BOLEX
INTERNATIONAL S.A.

SPARE PARTS AND SERVICE INSTRUCTIONS

H16M-RX-SB 251 501 →

H16EBM 300 401 →

Fig. 2

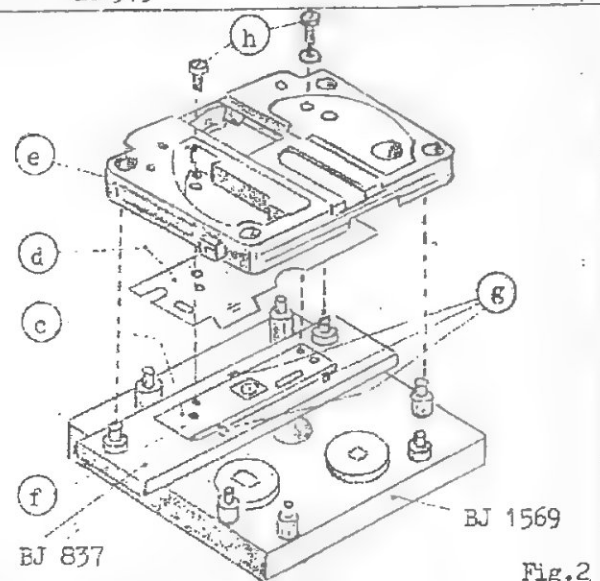
- F) Le gabarit de centrage BJ-1569 est mis hors-cours. Pour positionner le support de centrage du couloir BJ-837 sur le porte-objectif, planter 2 guides cylindriques BJ-1353 dans les 2 trous situés de part et d'autre du couloir.
- D) Die Zentrierlehre BJ-1569 ist nicht mehr verfügbar. Zur Einstellung der Filmbühne-Zentriervorrichtung BJ-837 auf dem Objektivhalter werden 2 Zylinderführungen BJ-1353 in die beiden Löcher der Filmbühne eingeführt.
- E) Centering gauge BJ-1569 is no longer available. In order to position the film gate centering device BJ-837 on the lens holder, introduce the 2 cylindric guides BJ-1353 into the 2 holes of the film gate.

Porte-objectif
Objektivhalter
Lens Holder

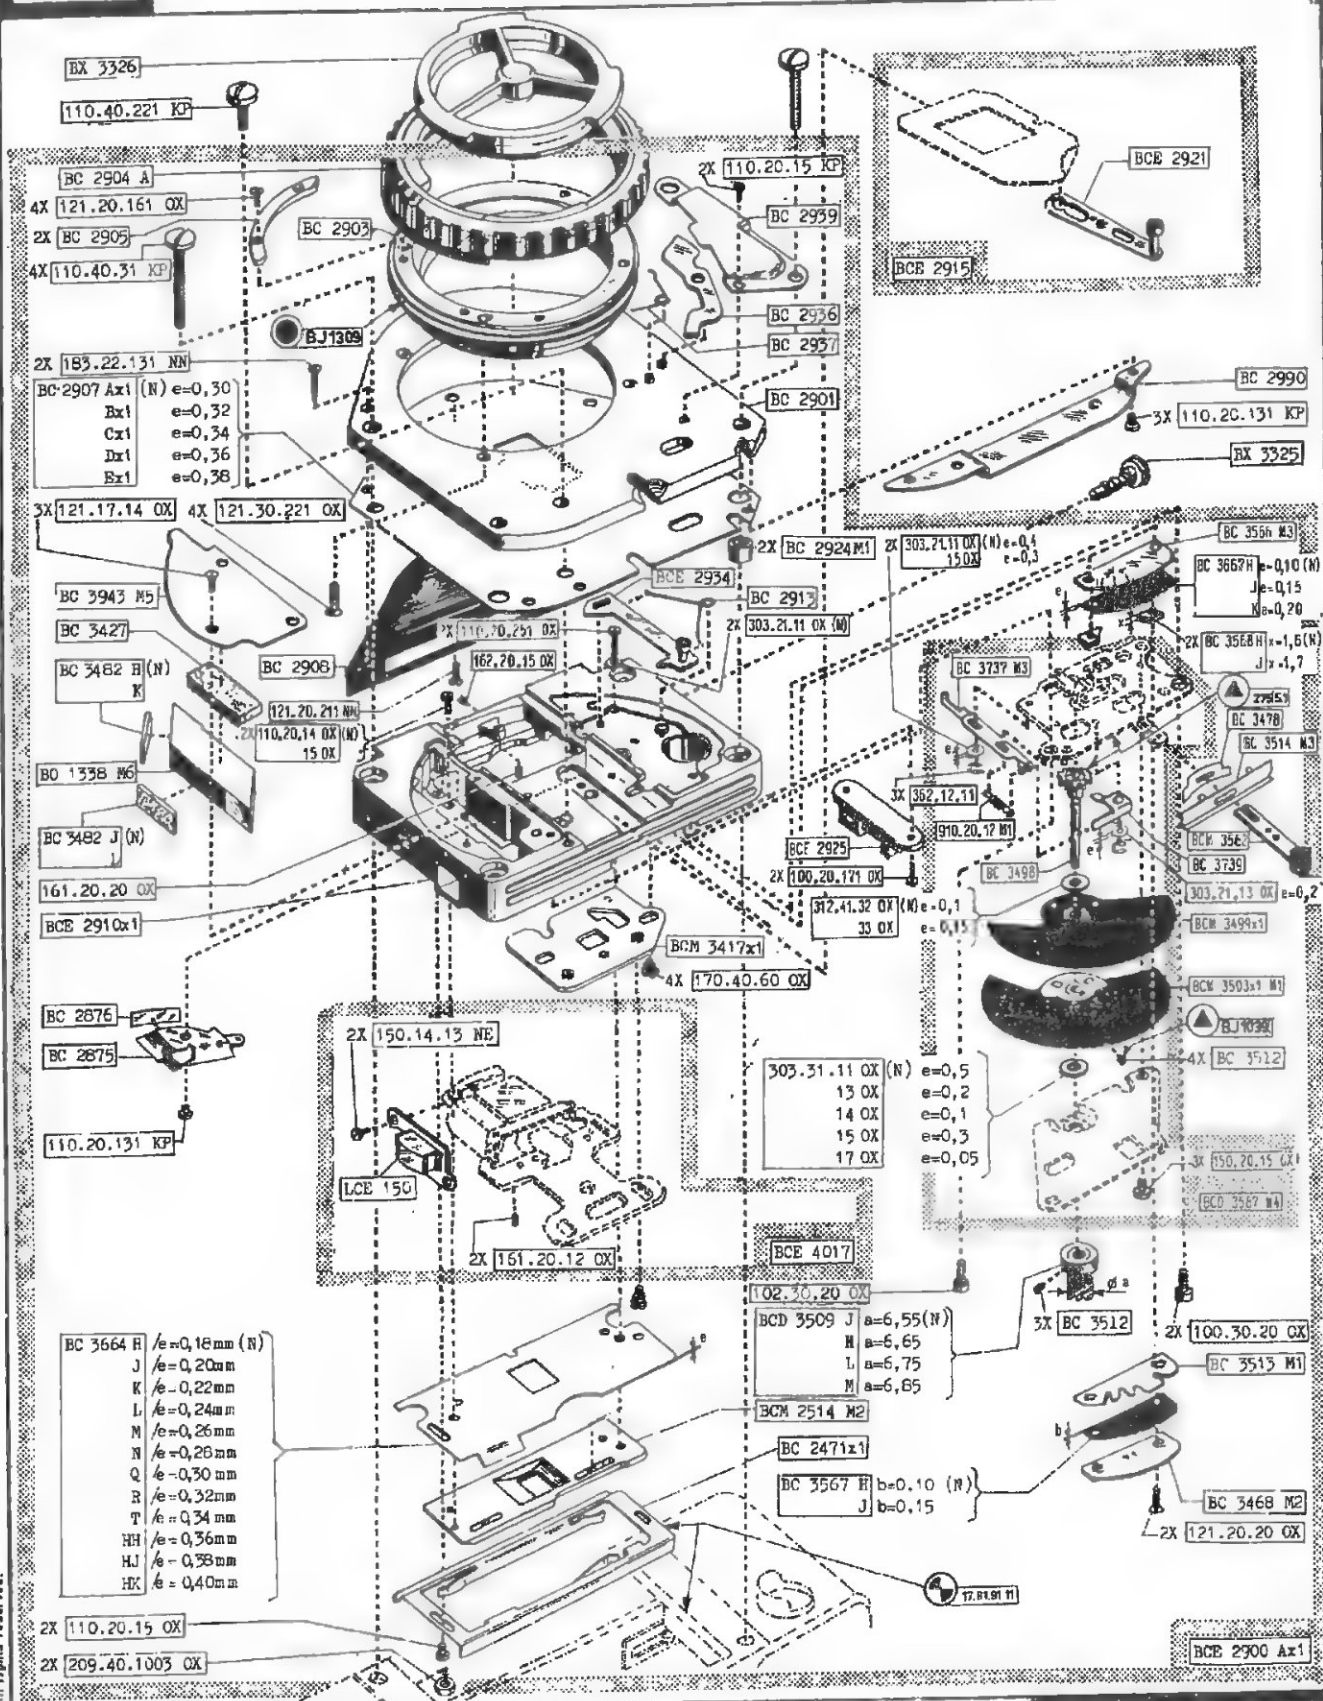
1 ^a Anciennes pièces Alte Teile Former parts	1 ^a Nouvelles pièces Neue Teile New parts	1 ^a Observations Bemerkungen Remarks
1 (BC 2907 Ax1 +) { " 8x1 +) { " Cx1 +)	BC 2907 F (H) e= 0,44 G e= 0,46 H e= 0,48	(F) Nouvelles variantes de caches et suppression de - 3 variantes. (D) Einführung von neuen Gleitfiltern und Wegfall von 3 Ausführungen. (E) Introduction of new filter holders and suppression of 3 versions. 11.71
2 (BCE 2925+) XXXXXXXXXXXXXXXXXXXX 2X (100.20.171 0X+)	BCE 2925 M2 2X (120.20.161 M1)	(F) Fixation du support claquette modifiée pour éviter un court-circuit avec les contacts. Vis à tête conique remplace vis à tête plate. (D) Änderung in der Befestigung des Startmarkierungshalters zur Vermeidung eines Kurzschlusses mit den Kontakten. Die Flachkopfschraube wird durch eine Zylinderschraube ersetzt. (E) Modification of the clapper support fixing to avoid a short-circuit with the contacts. The flat head screw is replaced by another one with cylinder head. 11.71
